PRODUCT UPDATE

Air Bleed Filter Orifices

5R110W TorqShift Transmission

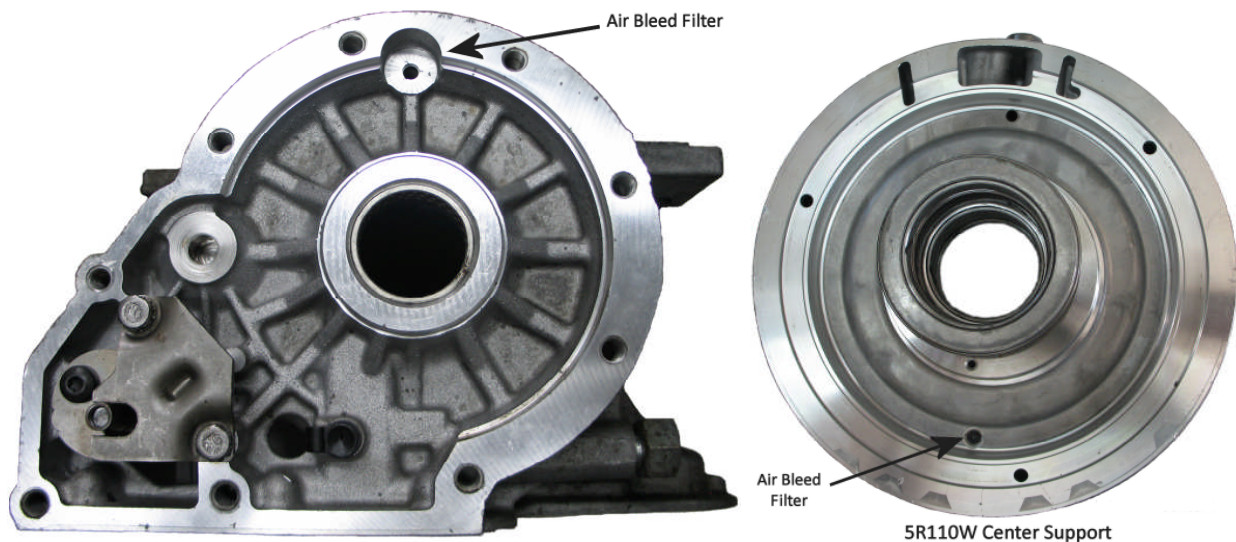
The following update has been added to our overhaul kits T136002A and T136002AP, built with date codes of 8/27/2008.

As pictured these filters are located in the rear of the transmission case and the center support and are easily removed with a small punch and hammer and are installed the same way and then staked in place.

These filters can be easily damaged by contamination and heat and should be replaced during the building of this unit.
